MEMORANDUM

To: Development Review Board
From: Mary O'Neil, AICP, Principal Planner
Date: November 6, 2019
RE: ZP20-0367CA; 27 Colchester Avenue

Request: 2,860 sf addition to Torrey Hall for improved ADA accessibility, to include stairs and elevator for all three stories and basement. Associated landscaping, walkways and relocation and rearrangement of 22 existing parking spaces. Request for extended permit life of 5 years within two phases. Request for specific days and hours of construction.

Map 4.5.2-4 ICC-UVM Central Campus and Height Overlay

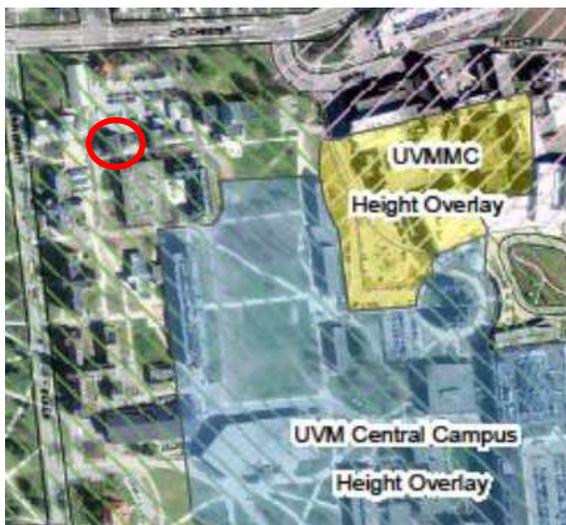
The proposed stair/elevator tower is not within the UVM Central Campus Height Overlay (see image.) It does not exceed the height of the tallest existing structure within the core campus, or the elevation of a plane running parallel to sea level from the point defined above. **Affirmative finding.**
